# Access Compliance Report Public Rights-of-Way (Curb Ramps)

Main Street: TIGERTAIL\_DR Cross Street: OAK\_WAY\_DR Location: NW

ADA ID: RPRK211208111712 Ramp Type: Type 4 - Parallel Initial Pass/Fail: Fail Overall Compliance: No Severity Score: 15

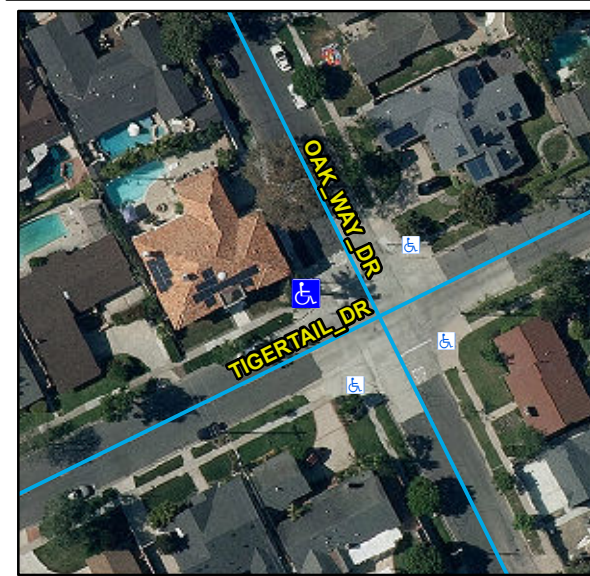
OC Std/PROW:  
**R304.5.3, STD 1115**

| Compliance | Description                   | Data       | Compliance | Description                   | Data |
|------------|-------------------------------|------------|------------|-------------------------------|------|
| No         | Ramp Cross Slope LT (%)       | 2.5        | No         | Ramp Cross Slope RT (%)       | 6.5  |

Possible Solutions:  
**Remove & Replace Curb Ramp With Two New Directional Ramps or Equivalent.**
